### **Comment 5 Arjan de Heer**

CLAUSE: 5.9

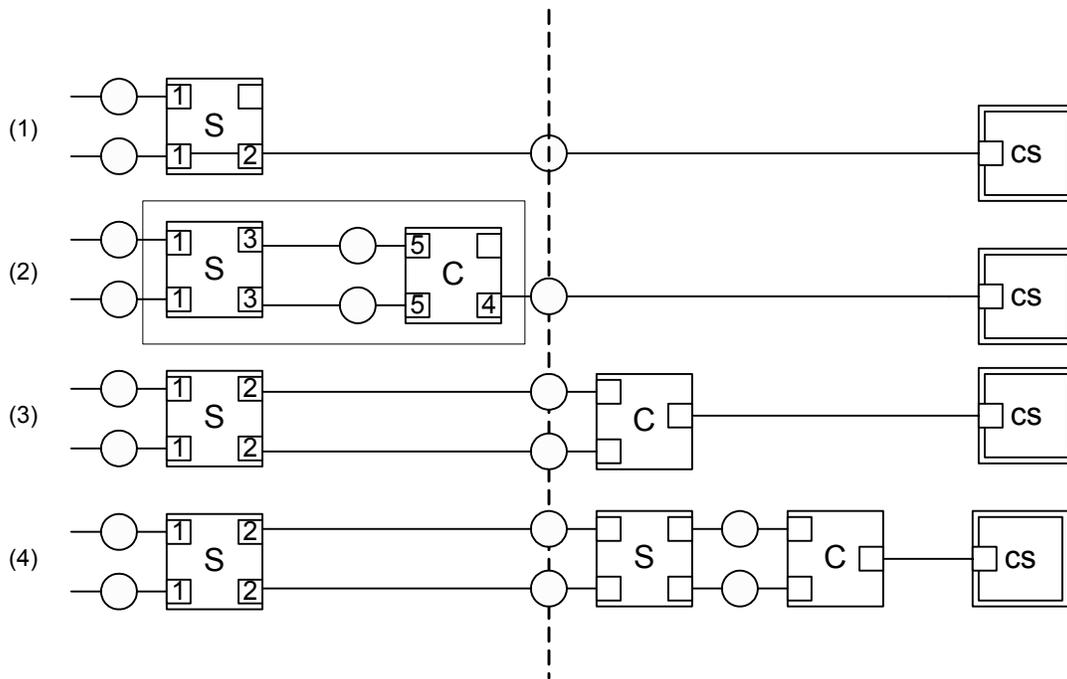
Each port of the Service-VLAN aware Bridge connects to either.. Connects to, or operates as? Terminology is confusing: In the provider bridge there is a customer network port, but this does not necessarily connect to the customer, this is done by the provider edge port in some cases.

These two names are orthogonal to each other. One is related to functions the other to the location in the network. There is no 1:1 mapping, it is not always the edge port that does the selection. This leaves a provider bridge with the following types of externally visible ports:

The 4 external visible interface should be described in section 15.

Change naming as suggested

Discuss. It is still not clear to the editor what should be done with the proposed taxonomy, though the analysis is appreciated. In particular, labelling a port a "translating port" doesn't seem to have much meaning if it only translates one out of 4096 VLANs. I think the above taxonomy and the further complications that become apparent when additional connection scenarios are considered, point to the fact that no satisfactorily short port naming scheme will suffice to uniquely identify the ports function, role in the network or piece of equipment, and the ownership or control over the things that the port connects. It takes quite a bit of clause 15 and 16 to both identify all the interface properties and the service selection and segregation aspects. Attempts to build on Arjan's suggested scheme also run into difficulties with the number of reserved words and words with loaded meanings. Using "service" and "interface" is fraught with difficulty. The terms "perimeter" and "boundary" might be acceptable, "border" is a little overloaded (BGP), as is "interior". The following diagram is intended to help the discussion by showing all the separate reference points that it might be useful to have names for (for simplicity provider-to-provider connections have been excluded), and discussing some of their properties. On the left of the diagram are items of equipment that are physically secured by the provider, a dotted line separates these from the items of equipment on the right which are vulnerable to customer or third party intrusion (intrusion into the equipment, not just into the connecting links). The diagram does not attempt to show who "owns" any item of equipment. S-VLAN aware components are labelled S, C-VLAN aware components are labelled C, and the label "cs" for "customer

The ports labelled ‘1’ all have the characteristic that they can carry traffic for any customer.

The ports labelled ‘2’ all have the characteristic that they should only admit traffic to a service instance owned by the attached customer (the one who owns the ‘cs’ shown). They must not allow frames to ingress the network for any other service instance i.e. their P-VID must be set correctly and the combination of the S-VID member set, ingress rule checking, and translation table must not allow frames to ingress to an unauthorized service instance either.

The ports labelled ‘3’ also have to perform this provider network ingress checking function, since the C-VLAN aware component in scenario (2) will not screen out S-tagged frames. It is a matter of supreme indifference to an attacker that he may be told not to send such frames. So the Ports labelled ‘3’ are very much like those labelled ‘2’ except that in any useful scenario they each receive frames, untagged, for only one service instance. And of course they are internal to a Provider Edge Bridge.

The port labelled ‘4’ cannot only connect to a single customer, and the ports labelled ‘5’, by virtue of being on the same C-VLAN aware component can only serve a single customer.

Originally Ports '1' and '2' were called "Provider Network Port" and 'Customer Network Port' which reflects my own experience in deploying scenarios (1) and (3). However it seems clear that a Port '4' wants to be called a 'Provider Edge Port', at least for best fit with discussions in other forums. So we currently have:

Port 1 - Provider Network Port  
Port 2 - Customer Network Port  
Port 3 - ?  
Port 4 - Provider Edge Port  
Port 5 - ?

Port 1 - (Provider) Network Port  
Port 2 - (Provider) Edge Port  
Port 3 - (Provider) Edge Port (internal)  
Port 4 - (Provider) Customer Edge Port  
Port 5 - (Provider) Access Port
